**ANSI/ASHRAE Addenda l, m, n, o, and s to
ANSI/ASHRAE Standard 62.1-2007**

Ventilation for Acceptable Indoor Air Quality

Addendum I to 62.1-2007

~~Figure D-1 Ventilation system schematic.~~

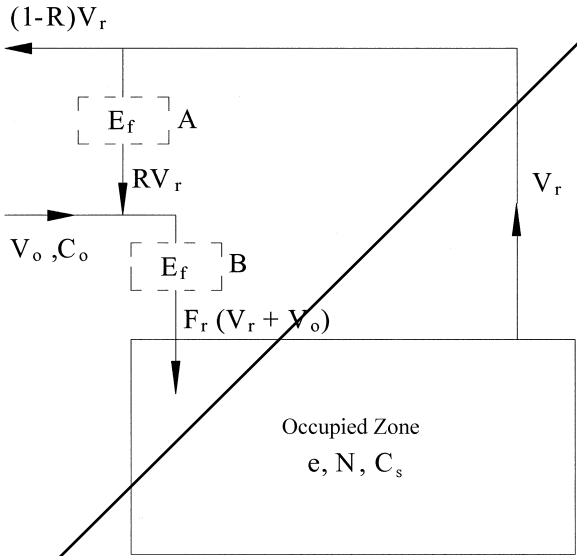
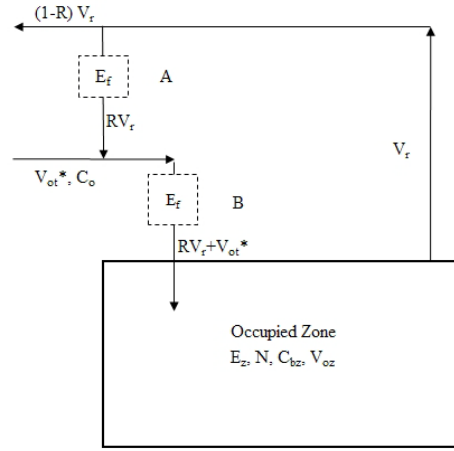
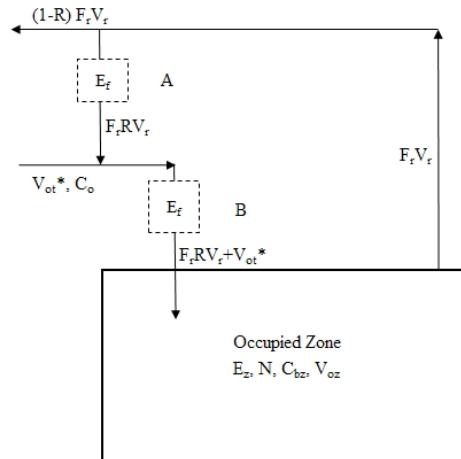
Figures D-1 and D-2 show ~~D-1 shows~~ representative single-zone systems. A filter may be located in the recirculated airstream (location A) or in the supply (mixed) airstream (location B).

Delete the existing Figure D-1 and insert new Figures D-1 and D-2 as shown.

Figure D-1 Ventilation system schematic—constant volume system with no infiltration/exfiltration. (* $V_{ot} \equiv V_{oz}$ for single-zone systems.)

Figure D-2 Ventilation system schematic—variable air volume system with no infiltration/exfiltration. (* $V_{ot} \equiv V_{oz}$ for single-zone systems.)
